**Report: Punchlist**  
**Function: Test, Adjust, & Balance**  
**Date: 05/30/2025**  
**Completed By: National TAB**

## Seven Hills School (Cincinnati, OH)

## Issue List

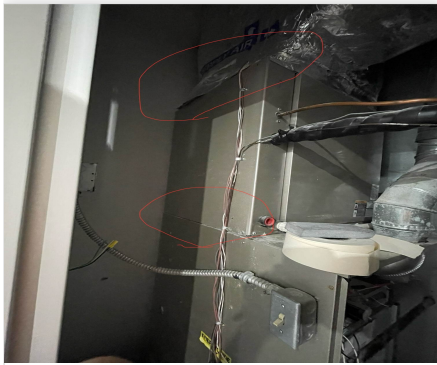
**Issue Name :** AHU-1 Not Functional  
**Description :** AHU-1 lost power to its main disconnect and must be re-connected. Spoke with electrician on site and he anticipates it will be ready Tues, June 3rd.  
**Created By :** National TAB                      **Assigned To :** National TAB - Jordan Best  
**Status :** Closed  
**Priority :** High                                      **Asset Tag :**  
**Originated Date :** 05/30/2025 - Jordan Best - National TAB
